**REDTAIL RANCH**

**PRELIMINARY PLAN AND FINAL PLAT**

**LETTER OF INTENT**

**JULY 2018**

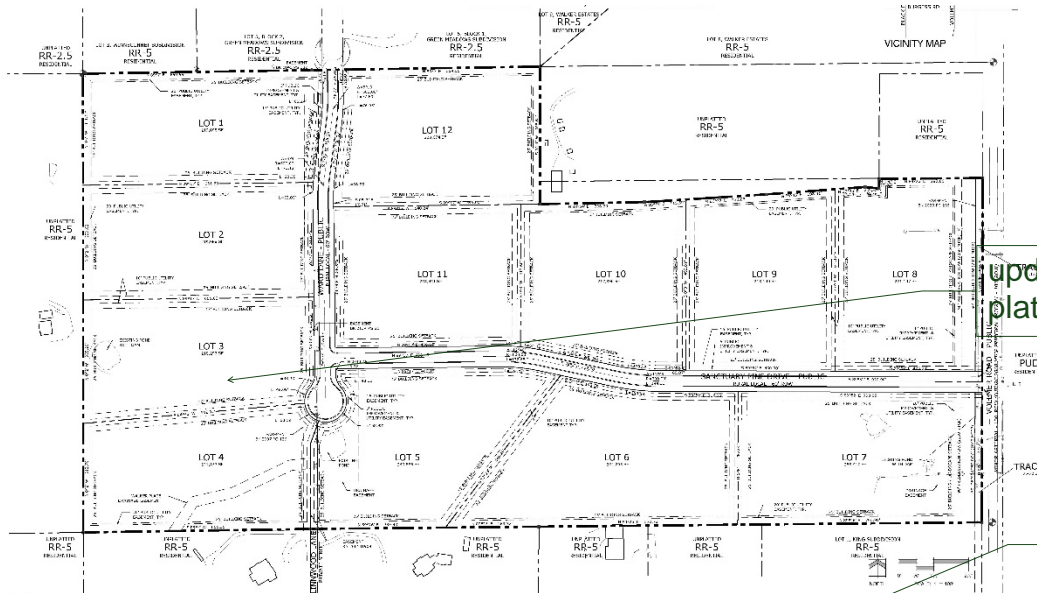
Your also requesting to vacate the existing sub lots here and replat together with....

See preliminary plan LOI redlines.
